## Connecting Rod 818141A9 is No Longer Available

**Taking measurements**

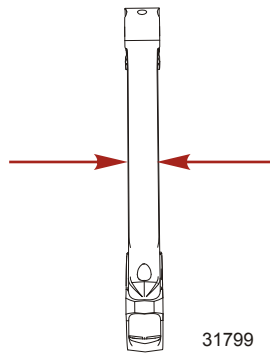
Connecting Rod P/N 818141A9 is no longer available; order six of P/N 625-847522A9 and replace them as a set. The replacement rod is not compatible with 818141A9 because of the weight difference and intermixing the rods will cause an imbalance in the rotating assembly.

To identify the connecting rod, use the following illustration to show where to measure the connecting rod and the following table for the specifications.

Connecting Rod Specifications	
644-818141A9	Approximately 10 mm (0.4 in.)
625-847522A9	Approximately 15 mm (0.6 in.)
